**SUBJECT: SPEX 2007-0030 & CMPT 2007-0017 Eastern Loudoun Sheriff's Substation at Rolling Ridge Elementary School, 2<sup>nd</sup> Referral**

**SUBJECT: SPEX 2007-0030 & CMPT 2007-0017 Eastern Loudoun Sheriff's Substation at Rolling Ridge Elementary School**

**SUBJECT:** SPEX-2007-0030, Eastern Loudoun Sheriff's Substation at Rolling Ridge

SUBJECT: **SPEX-2007-0030 Eastern Loudoun Sheriff's Substation  
at Rolling Ridge Elementary School -2nd**

Vicinity Map

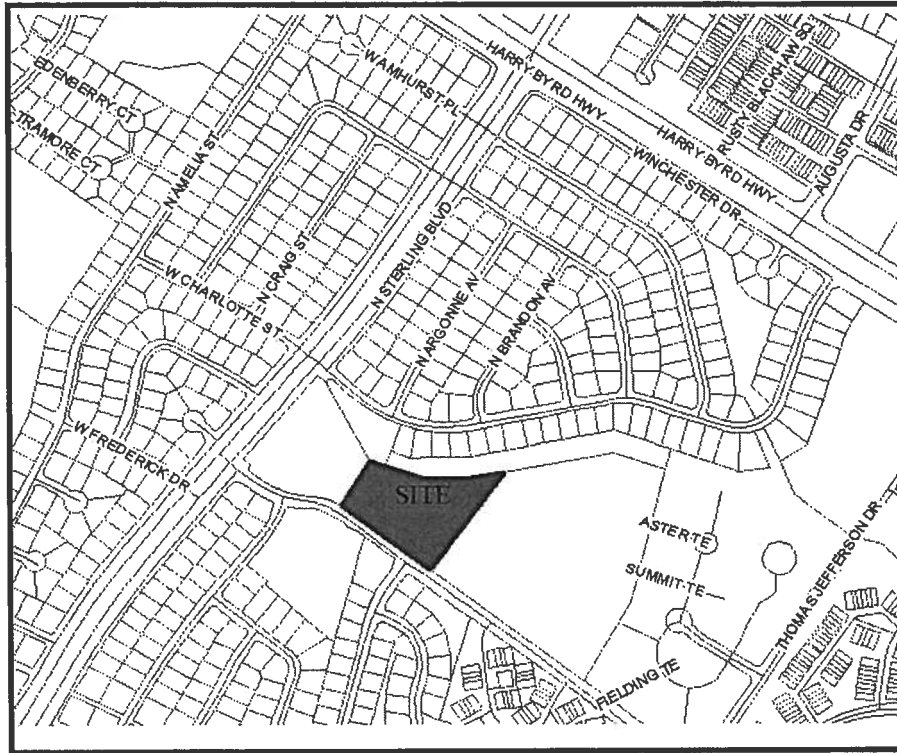
16. The Applicant needs to demonstrate to Staff how the requirements of Minimum Submission Checklist, J, Vicinity Map are being met. The Vicinity Map on Sheets 1 and 3 of the Plat is at the incorrect size and scale for the checklist, and structures within 200 feet of property lines are not shown anywhere on the Plat. Please revise or explain these discrepancies.

17. In addition to Comment 16, the Vicinity Maps shown Sheets 1 and 3 are at different sizes, yet labeled at the same scale. Also, the "Site" highlighted on the Vicinity Map appears to include the entire original parcel, not the 4-acre project-specific parcel. Please revise or explain these discrepancies.

**Issue Status: Please revise the Vicinity Map to highlight only the subject 4-acre parcel.**
